SUNDRY NOTICES AND REPORTS ON WELLS

Jicarilla 200 #1 (D-21)

PROPOSED P&A PROCEDURE  
Benson-Montin-Greer Drlg. Corp., Inc.  
Jicarilla 200 #1 (D-21)  
660' FNL-825' FWL Sec. 21-T27N-R1W

**B-M-G DRILLING CORP., INC.**  
**JIC 200 #1 (D-21) API #30-039-08126**  
**660' FNL-825' FWL, SEC 21-T27N-R1W**

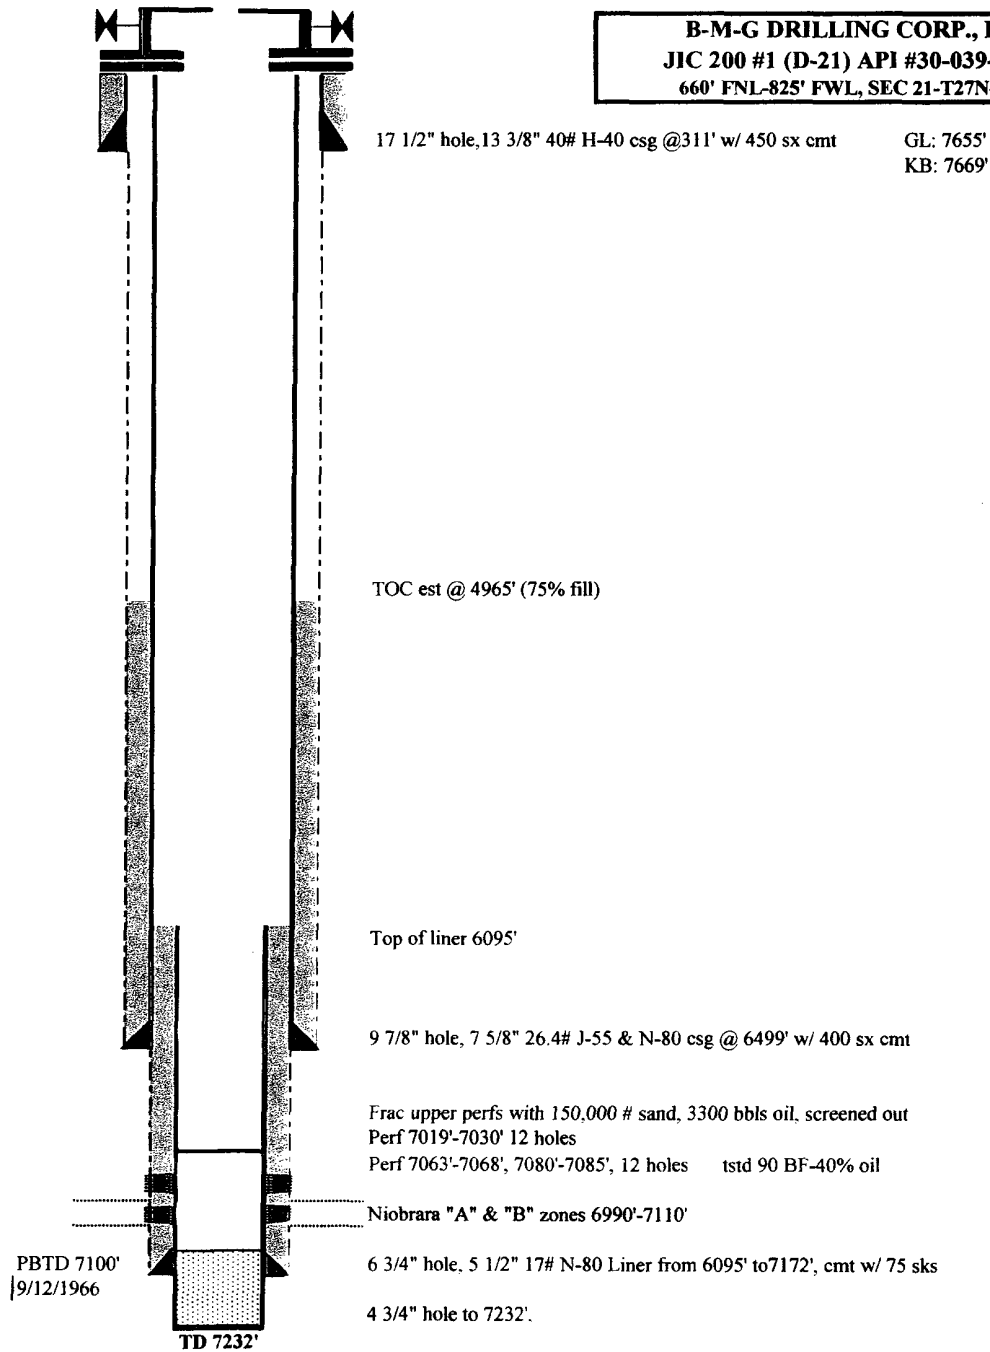
1. MIRU A Plus Well Service. RU Basin Wire Line Co., run CBL from PBSD (7100') to cement top estimated at 5000'. GIH with 2 7/8" tbg, set 5 1/2" cement retainer at 7000', squeeze Niobrara perms with 50 sks regular cement. → place cement on top retainer to 6615' & excess fall to 5530'-5430'

2. Assuming Mesaverde Zone is covered with cement (top of Mesaverde is 5480") → 3440' perf squeeze holes at base of Pictured Cliffs at 3600', set cement retainer at 3575', attempt to circulate back to surface. If successful, pump enough cement (5.12 ft fill-up per sk of cement) to cover Ojo Alamo at 2800'. If unable to obtain circulation, squeeze with 25 sks cement, perf additional squeeze holes above Ojo Alamo at 2825', set cement retainer at 2850', squeeze with 25 sks cement.

Nacimiento plug 1616' - 1516'

plug #1 7000' - 6615' Gallup  
#2 5530' - 5430' Mesaverde  
#3 3440' - 3122' PC/Fr & Ojo Alamo  
#4 1616' - 1516' Nacimiento  
#5 360' - surface
